## **CRANE STREAM AND WETLAND MITIGATION SITE**

**Response to DMS Comments**

DMS Project ID No. 100165  
Full Delivery Contract No. 0302-01  
RFP No. 16-20190302  
USACE Action ID No. SAW-2020-01401  
DWR Project No. 20201292

**DMS Comments Received (Black Text) & Responses (Blue Text)**

Figure 1. Current Conditions Plan View

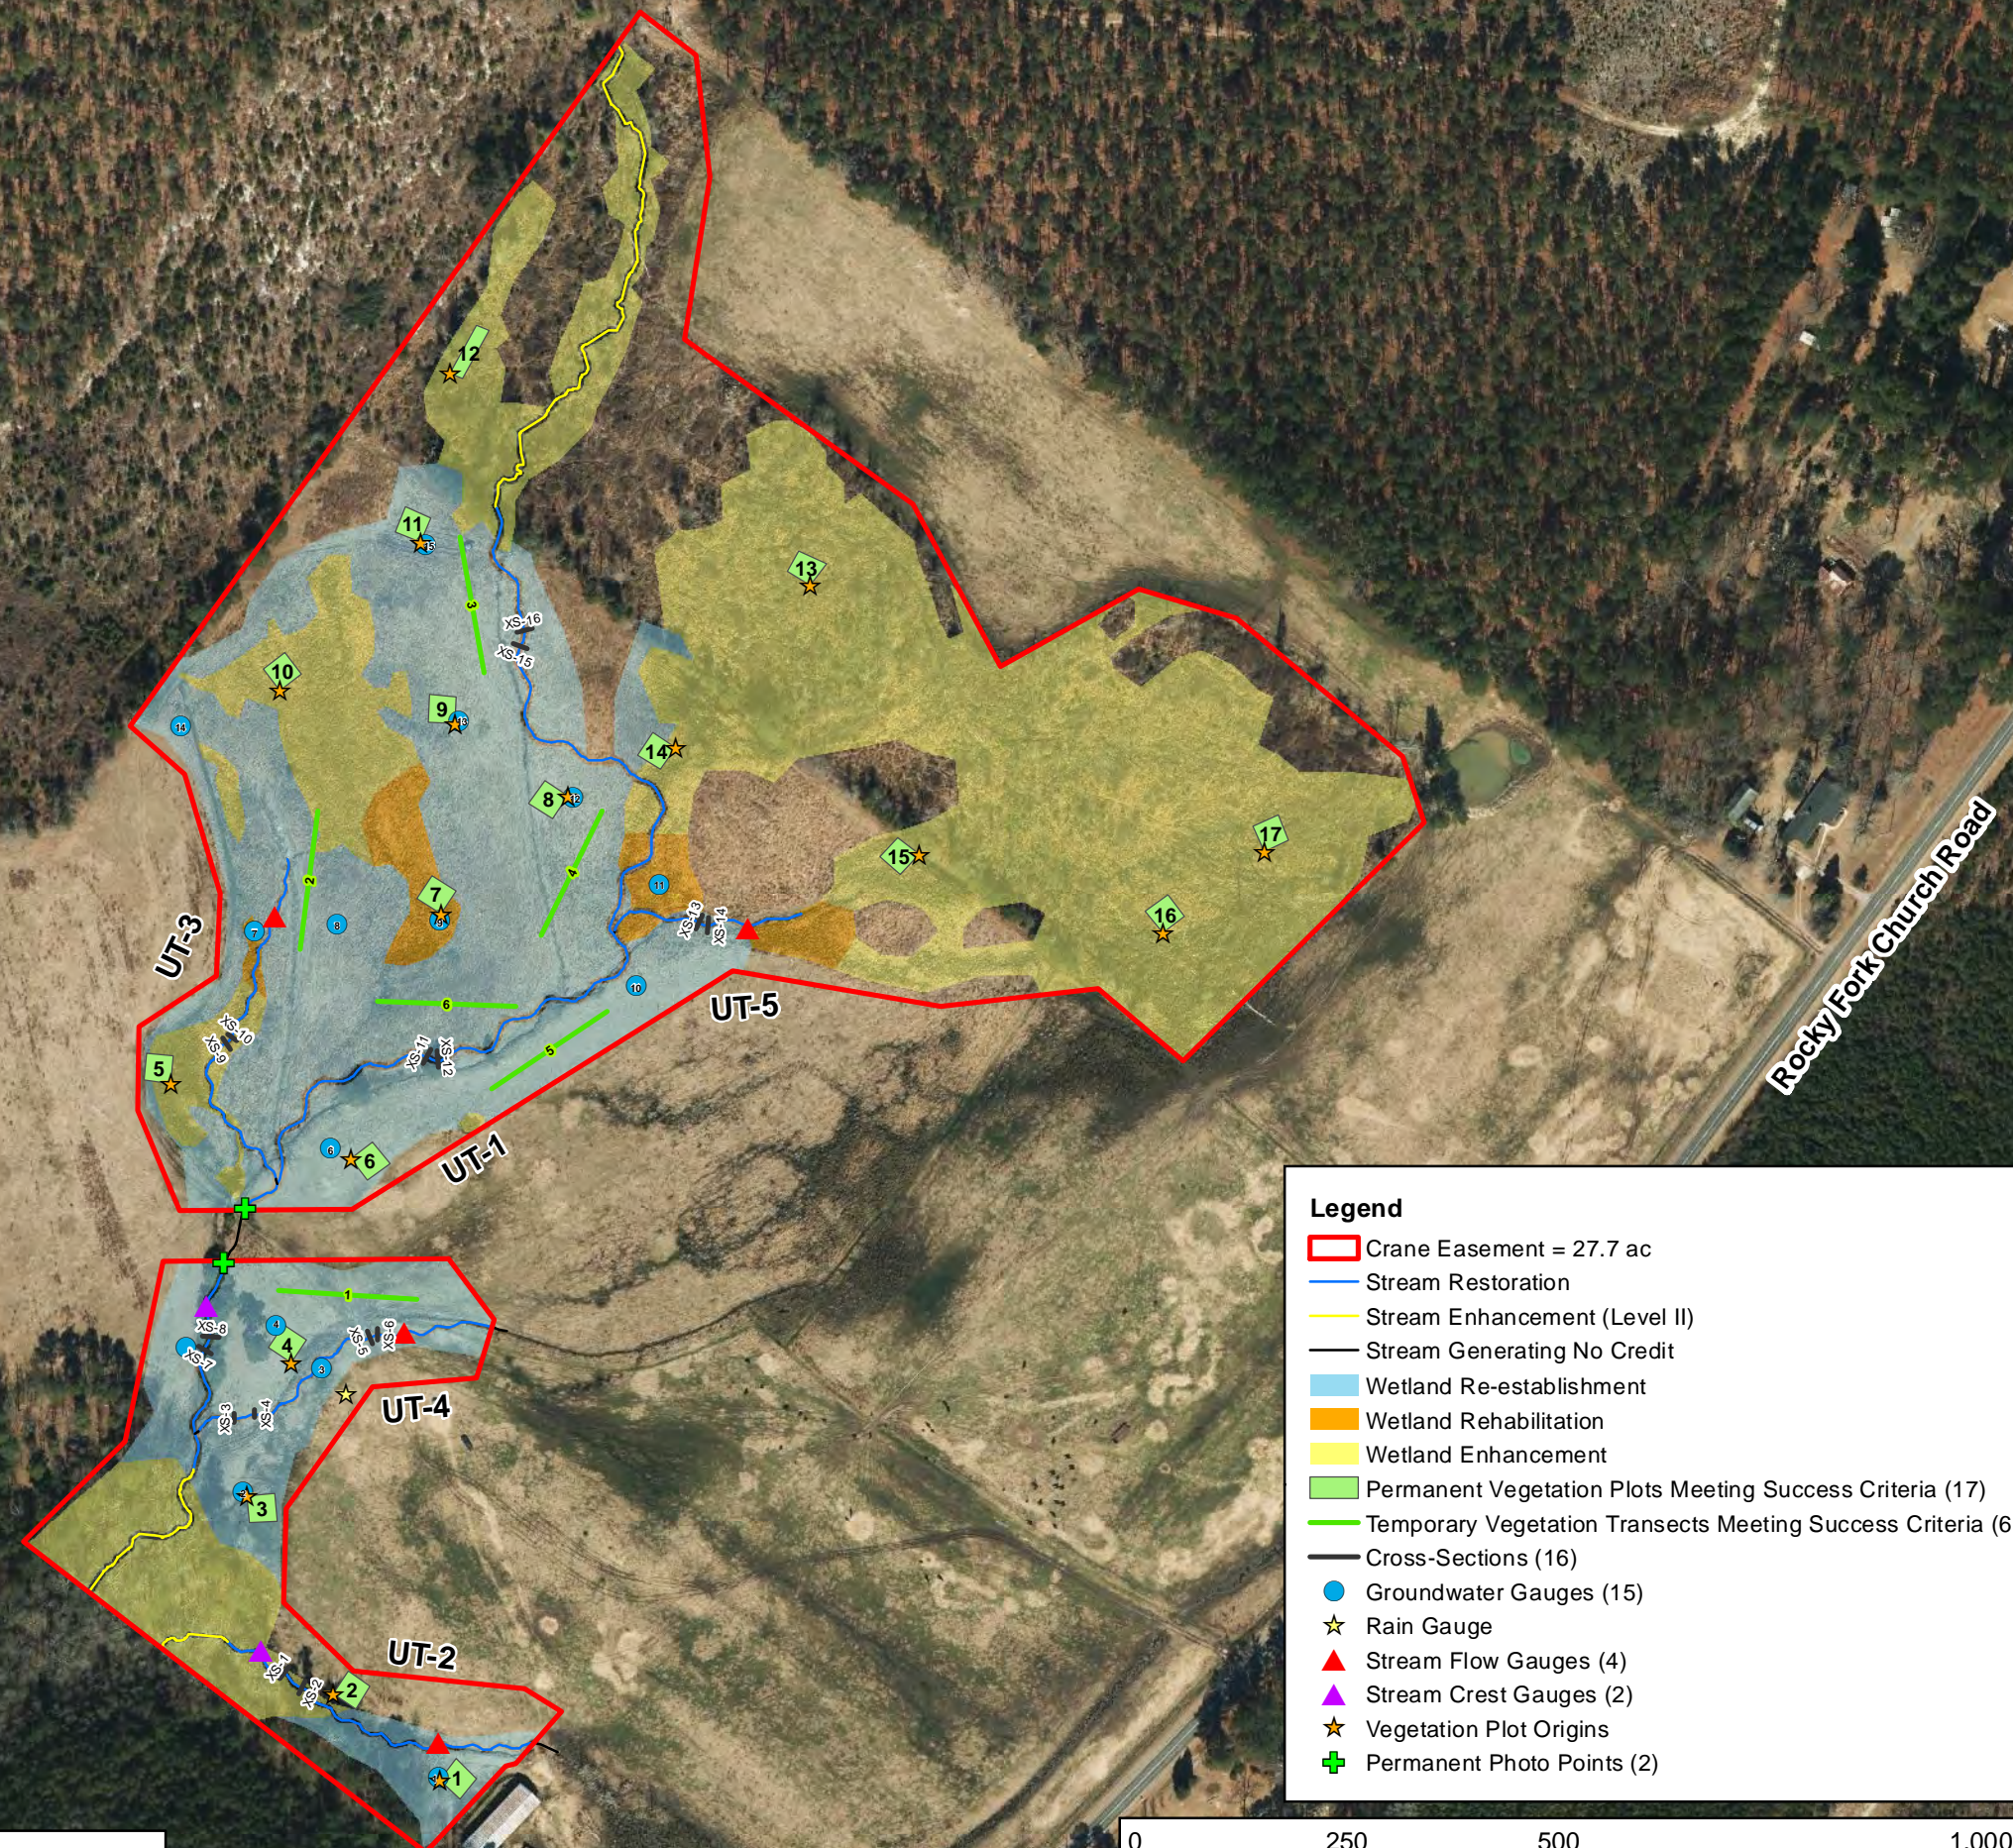
7. Figure 1 – Please differentiate purpose of stream gauges, i.e., crest gauge vs. flow gauge.  
Figure 1 was updated to differentiate crest gauges from flow gauges.

**PLAN AND PROFILE**  
UT1 STA 6+80 - 10+00  
**C5.00**

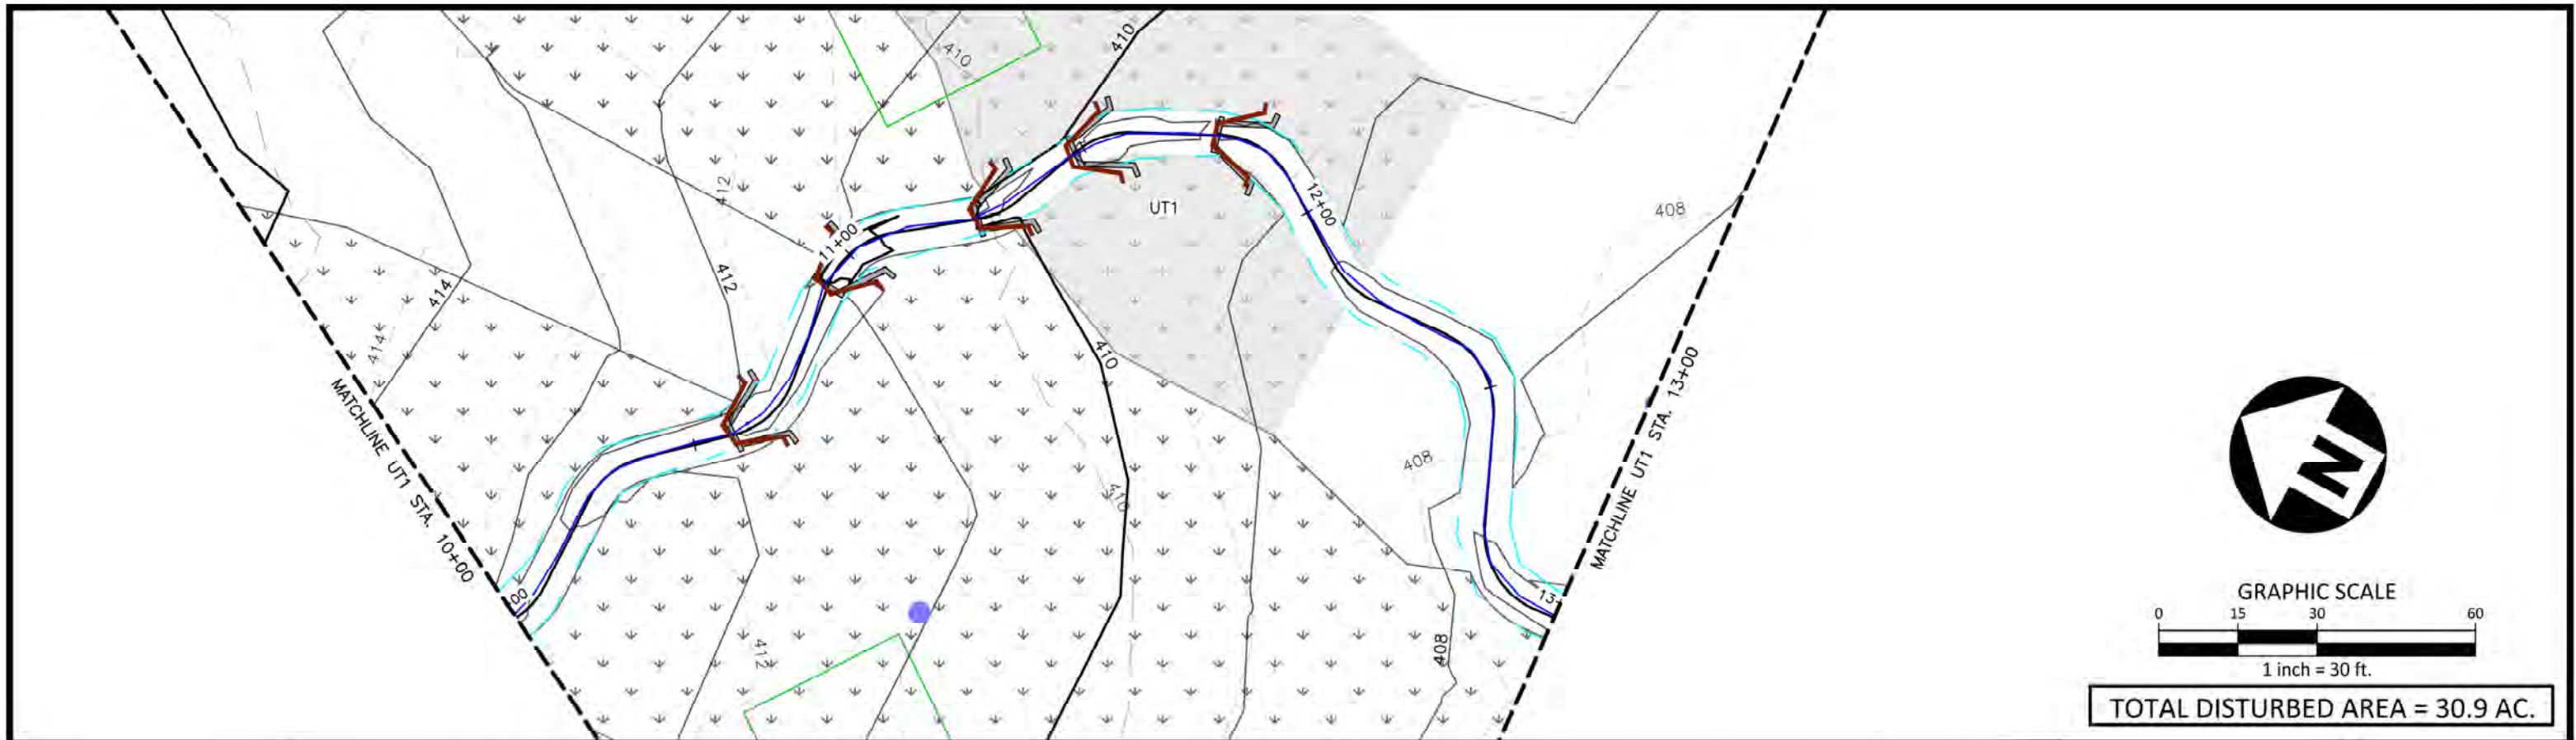
9. Sheet C5.00 – Please verify whether the riffle at UT1 Sta. 6+94 was surveyed. If not, please survey constructed riffles in the future.  
Constructed riffles will be surveyed moving forward- we apologize for missing this one.

**PLAN AND PROFILE**  
 UT4 STA 0+00 - 2+00  
**C5.12**

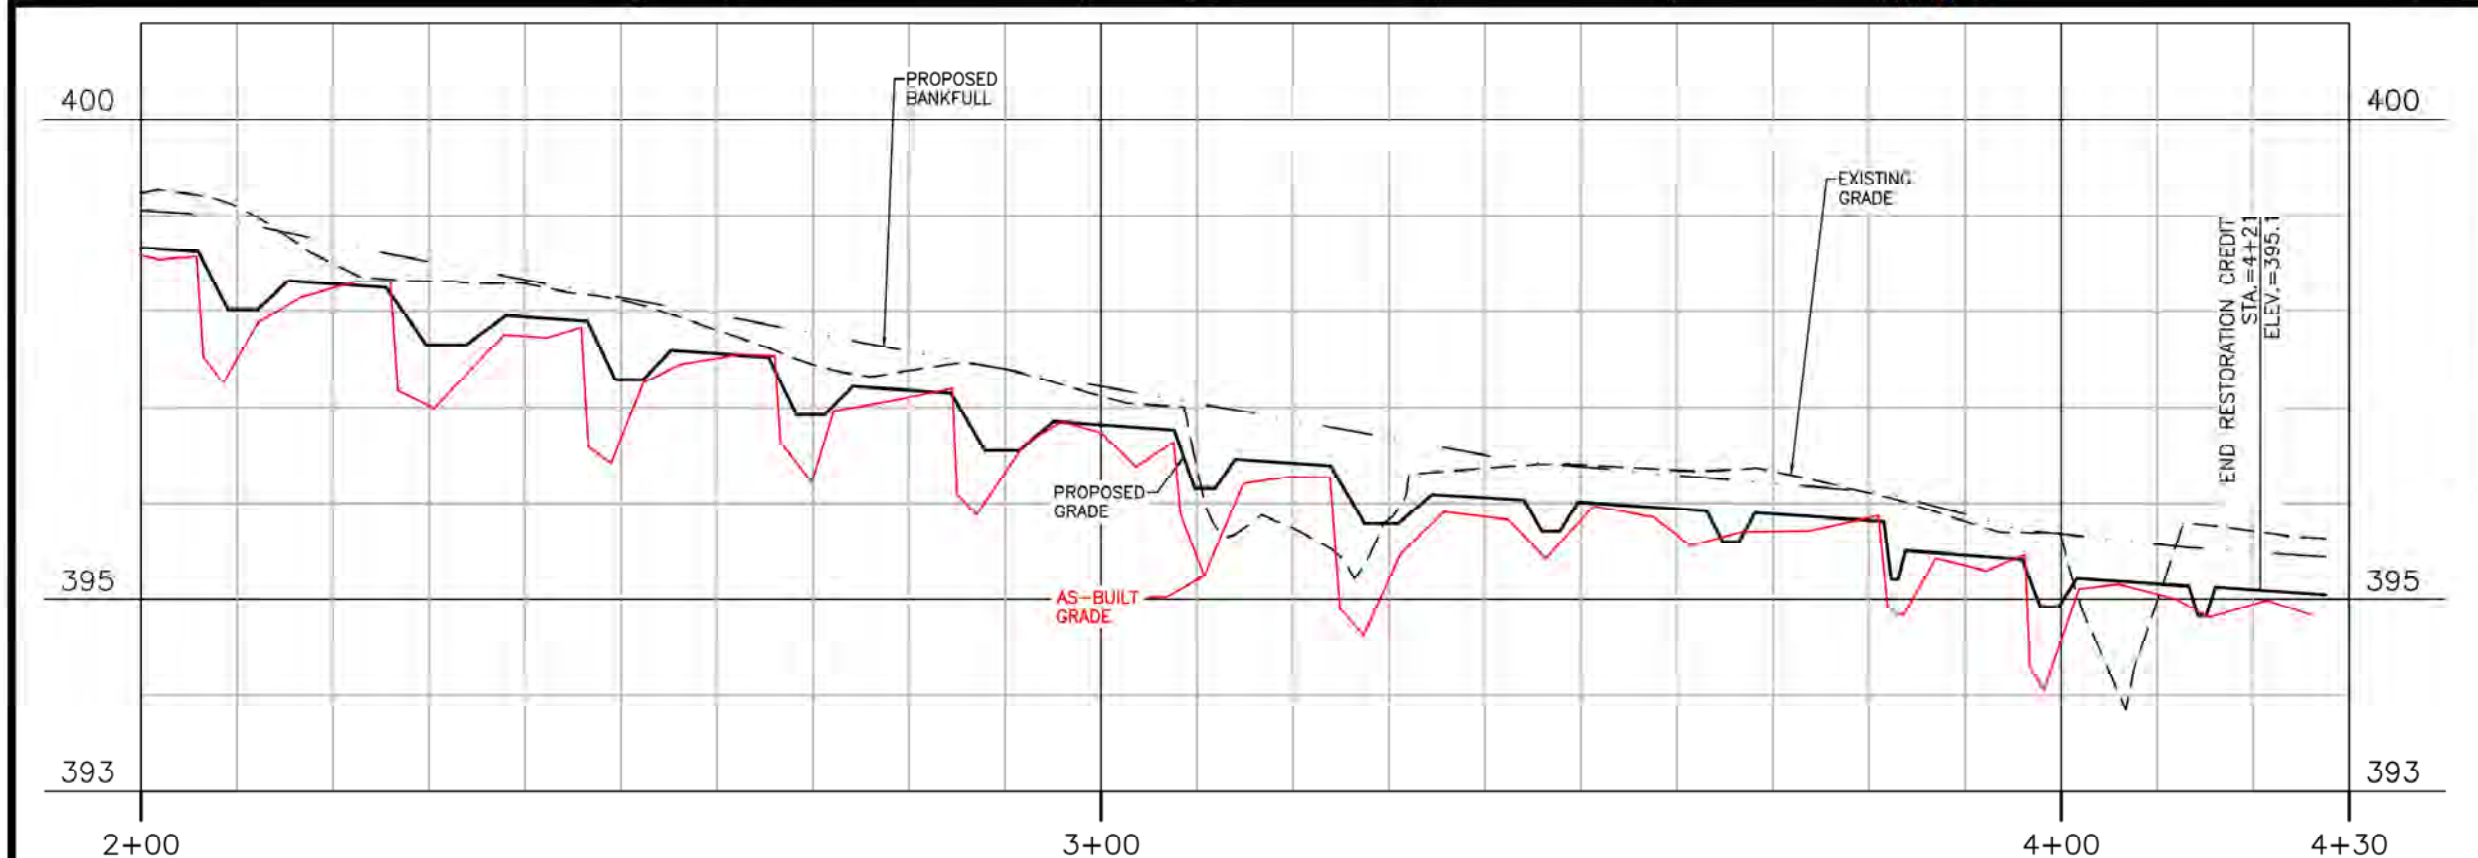
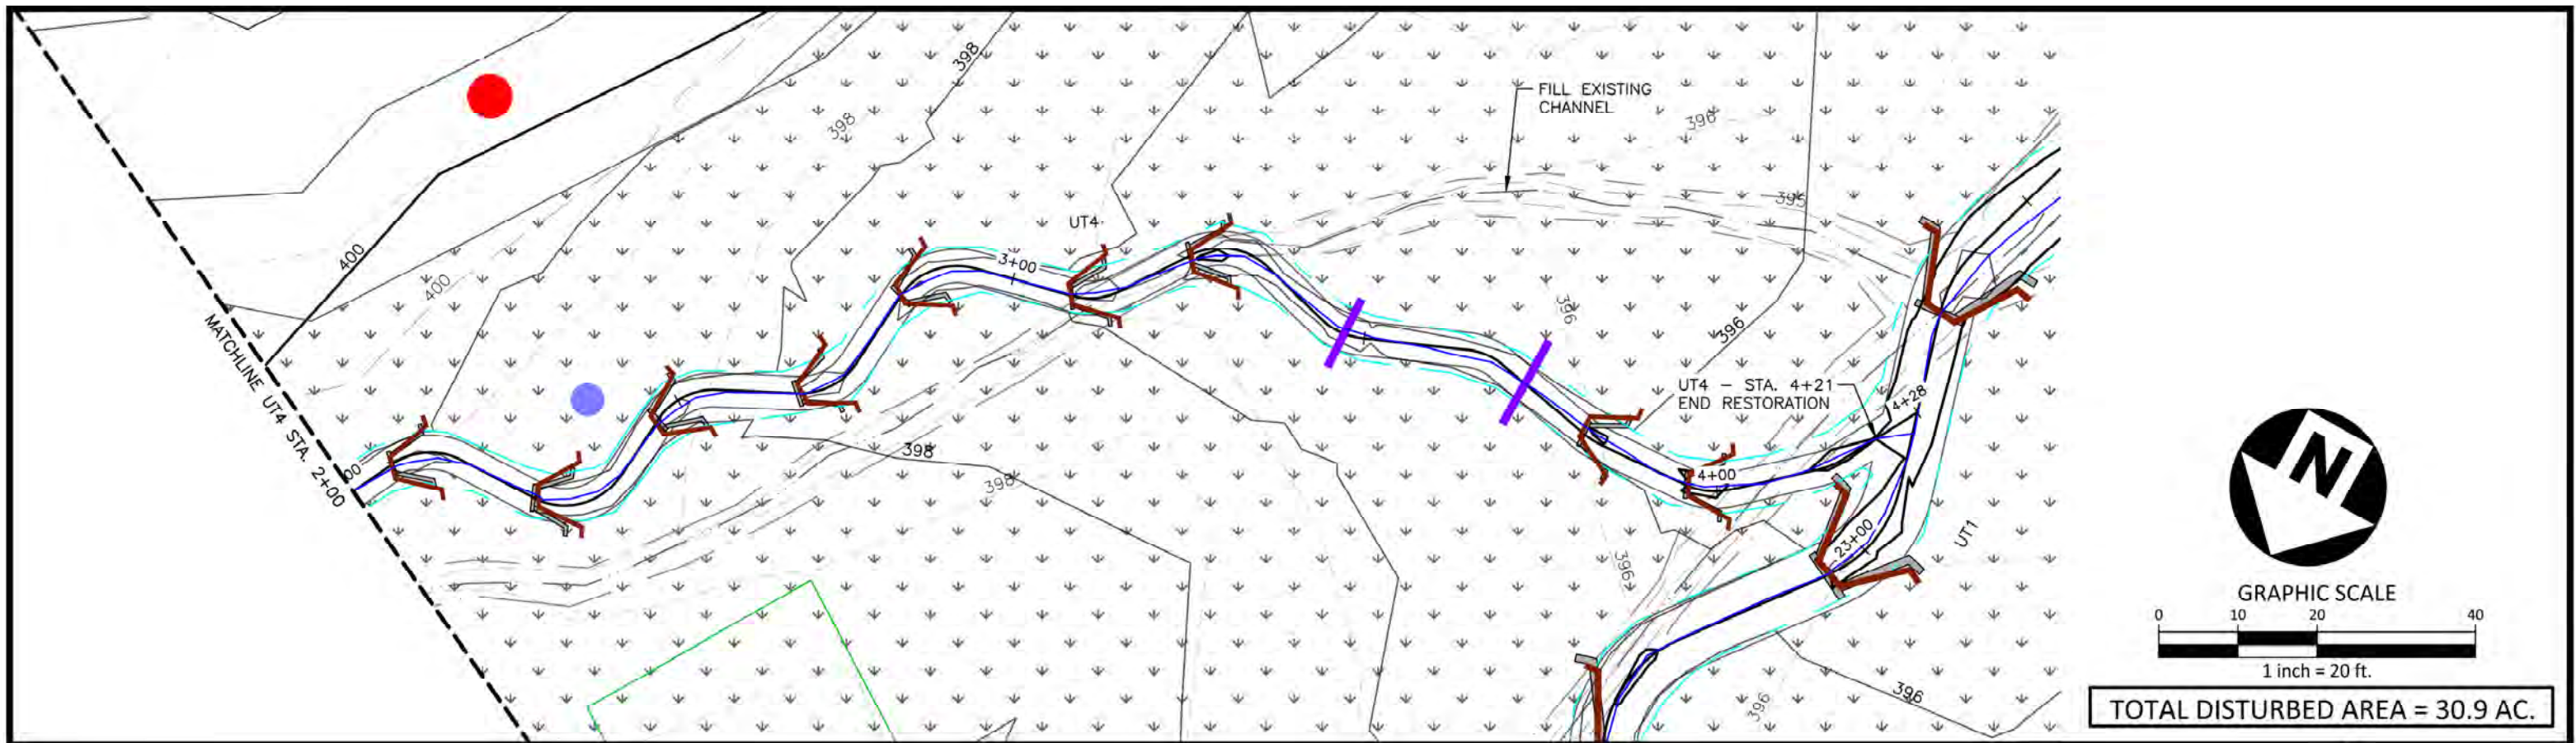
10. Please add in-stream crest and flow gauges to the drawings if they were surveyed (one is shown on Sheet C5.12, but not on any others).  
Stream gauges are shown in the revised 5/2/23 as-built drawings.
